Subject: 9/1-2/09 BOARD MEETING (Item 10: General NPDES Permit for Discharges of Stormwater Associated with Construction Activities (CGP))  
FSI 077026.3  
Delivered via email

Flow Science Incorporated (Flow Science) respectfully submits these comments on the addendum (Staff Change Sheet #1, dated August 17, 2009) to the Draft General NPDES Permit for Discharges of Stormwater Associated with Construction Activities (CGP) (dated April 22, 2009). On behalf of the California Building Industry Association (CBIA), the Construction Industry Coalition on Water Quality (CICWQ), and the Building Industry Legal Defense Foundation (BILD), Flow Science has previously contributed to comments submitted by the CBIA, including a detailed report entitled "General Construction Permit: Action Levels and Numeric Effluent Limits Analysis and Recommendation of Alternatives," dated June 24, 2009.

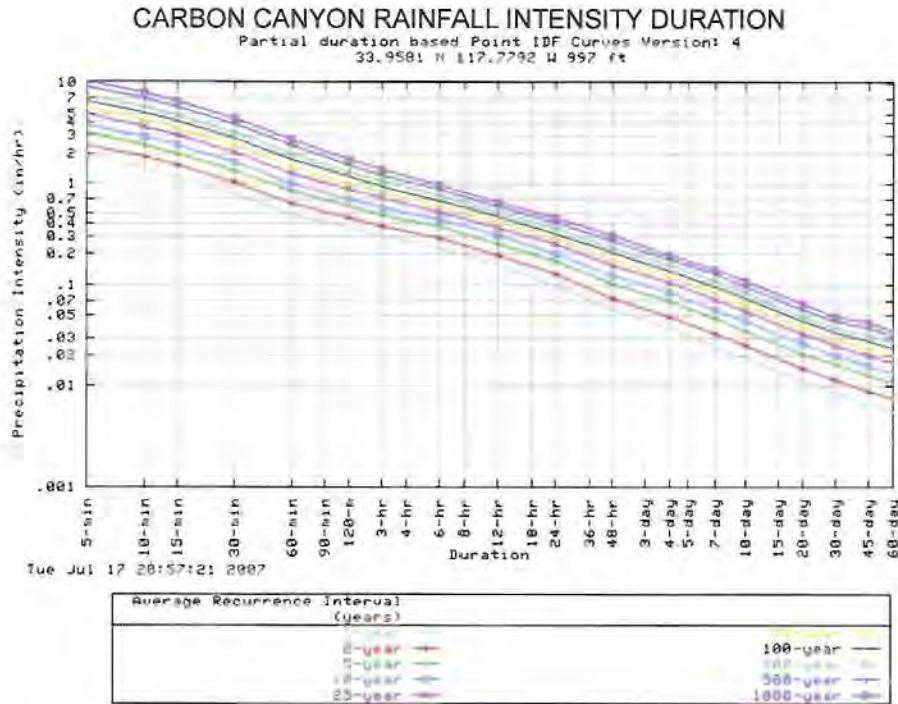
3. **Published, peer-reviewed studies and reports on in-situ performance of best management practices in terms of erosion and sediment control on active construction sites.** SWRCB Staff cite only one report (Horner, Guedry, and Kortenhof, 1990) and a comment letter from Dr. Horner to the State Water Board in support of the proposed NEL. The tests in Horner et al. (1990) were conducted in Washington State, and while a total of thirteen (13) storms were tested, the rainfall intensity for those storms varied from 0.009 to 0.119 inches/hour. Rainfall intensities higher than this are common in California, particularly in mountainous regions. For example, Wieczorek (1987)<sup>1</sup> observed rainfall intensities of up to 1 inch/hour in the La Honda area (Santa Cruz Mountains) in 1983. The California Stormwater BMP Handbook (January 2003, Appendix D) provides rainfall intensities for 19 locations throughout the State of California; the percent of time that a rainfall intensity of 0.1 in/hr is exceeded at these locations ranges from about 8% of the time (Bakersfield Airport, Palm Springs) to about 23% of the time (Oxnard, Santa Susana). An example rainfall intensity plot (for

Carbon Canyon, in Orange County) from NOAA<sup>2</sup> is shown below. This plot demonstrates that a one-hour rainfall intensity for a storm with a 1-year recurrence interval is about 0.5 in/hr in Carbon Canyon.
